HARTING Product Change Notification

PCN/24/001/C+N

Product range: Han / Han-Modular

Title: Han Megabit and Han Gigabit modules M2

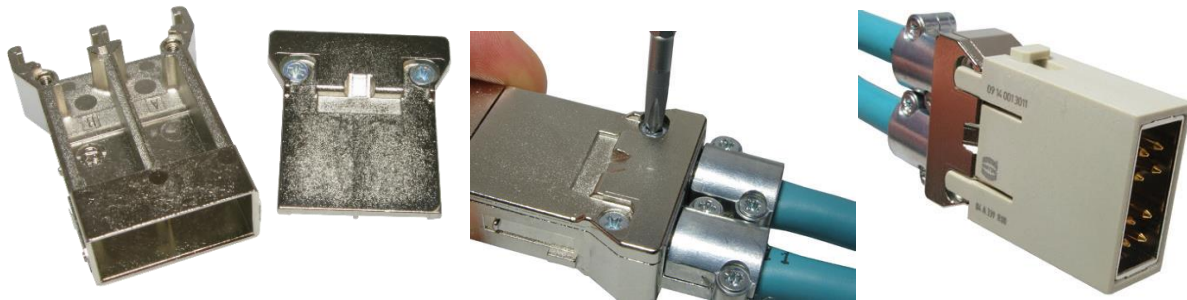
The cover fixation of the Han Megabit, Han Gigabit and Han Shielded modules is realized by two M2.5 screws with corresponding M2.5 thread in the housings. These screws will be changed to M2.5 self-tapping screws and a corresponding hole in the housings.

It has no influence on technical features or installation process

- Same type of delivery with pre-installed screws in the cover
- Same installation procedure (same screw drivers and tightening torques)
- Same technical features
- After final installation the screws are secured in the same way by the module
